Office Action Summary

10/635,585

ZAIC, DAVID

DETAILED ACTION

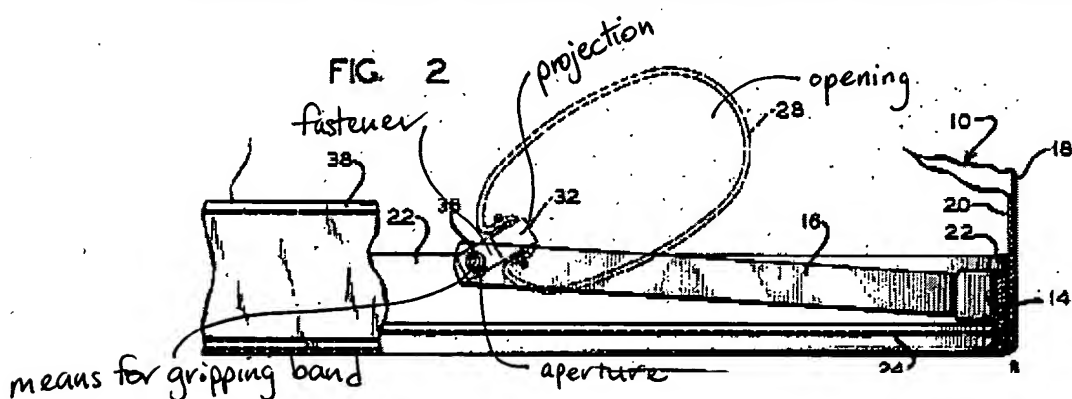
Mougel discloses an ear muff having a support with a fastener integral with a hoop 28. The fastener includes means for gripping band 16 wherein the means for gripping includes a perimeter defining an aperture. A projection extends into the aperture and the hoop 28 has a rail defining an opening. The hoop 28 is capable of being positioned in an expanded position and a compressed position since it is made from wire. A cover 12 is provided and sized to receive the hoop (see Figure below).

However, Mougel does not disclose that the cover is comprised of both an outer cover and an insulator disposed.

Wassell teaches an ear muff wherein the cover is comprised of an outer layer and an inner insulator to protect the user from cold, wind, snow or the like without impairing the hearing (see abstract).

It would have been obvious to one of ordinary skill in the art at the time the invention was made to provide the cover 12 of Mougel with two layers (i.e., an outer layer and an insulator) as taught by Wassell in order to protect the user from cold, wind, snow or the like without impairing the hearing (see abstract).
